UNITED STATES PATENT AND TRADEMARK OFFICE

APPLICATION NO.	FILING DATE	FIRST NAMED INVENTOR	ATTORNEY DOCKET NO.	CONFIRMATION NO.
10/821,737	04/09/2004	Jochen Schweinbenz	10191/3610	1521

Office Action Summary

DETAILED ACTION

Fig 1

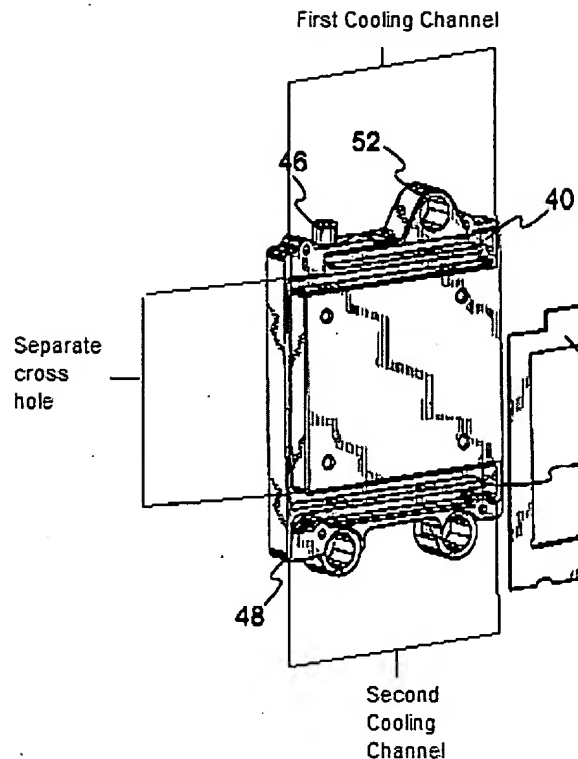
With respect to claim 10, Clamp et al. further illustrates that the separate cooling channels are connected by at least one separate cross hole (Running along the left side of the bottom as illustrated in Fig 2 and present office action Fig 1 below).

With respect to the applicants' remarks to claims 9 and 10 that, "It is obvious that no separate cooling channel is provided, since only one cooling channel is present", the examiner respectfully disagrees. The examiner respectfully notes that Clamp intentionally included several separate cooling channels to, "constrain the fuel to follow a convoluted flow path through the flow conduit to increase residence time and the effective heat transfer from the electronic components". Therefore the flow path (40) is comprised of several separate cooling channels connected by at least one separate cross hole as illustrated in present office action Fig 1 below
